Access Compliance Report

Public Rights-of-Way

Intersection ID: 27788	Main Street: PROVIDENCE_RD	Cross Street: PROVIDENCE_COUNTRY_CLUB_DR	Location: SW
ADA ID: 1F829549619A	Ramp Type: Para	Initial Pass/Fail: Fail	Overall Compliance: No
Codes/Mitigation Info/Possible Solution		Field Measurements/Component Compliance

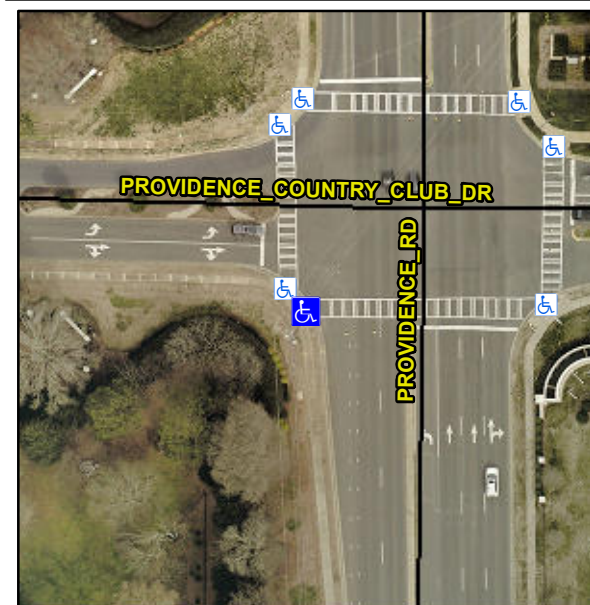
R304.5.1, R304.5.3

Compliance	Description	Data	Compliance	Description	Data
N/A	Ramp Length LT (in)	57.0	N/A	Ramp Length RT (in)	66.0
Yes	Ramp Width LT (in)	57.0	No	Ramp Width RT (in)	47.0
Yes	Ramp Slope LT (%)	8.0	Yes	Ramp Slope RT (%)	5.0
No	Ramp XSlope LT (%)	2.4	No	Ramp XSlope RT (%)	2.9
N/A	Landing Length (in)	N/A	N/A	DWS Provided?	N/A
N/A	Landing Width (in)	N/A	N/A	DWS Contrast?	N/A
N/A	Landing Slope (%)	N/A	N/A	DWS Length (in)	N/A
N/A	Landing X Slope (%)	N/A	N/A	DWS Full Width?	N/A
N/A	Landing Curb? (Y/N)	N/A	N/A	DWS Offset (in)	N/A
N/A	Shared Landing?	N/A			
N/A	Gutter Ponding?	N/A	N/A	Gutter Slope (%)	N/A
N/A	Gutter Lip Ht (in)	N/A	N/A	Gutter X Slope (%)	N/A
N/A	Painted X Walk1?	Yes	N/A	Painted X Walk2?	N/A
	X Walk 1 Direction	To E		X Walk 2 Direction	N/A
N/A	X Walk 1 Width (in)	103.0	N/A	X Walk 2 Width (in)	N/A
	X Walk 1 Slope (%)	0.2		X Walk 2 Slope (%)	N/A
	X Walk 1 X Slope (%)	0.8		X Walk 2 X Slope (%)	N/A
N/A	Ramp inside XWalk1?	Yes	N/A	Ramp inside XWalk2?	N/A

Remove & Replace Entire Ramp.
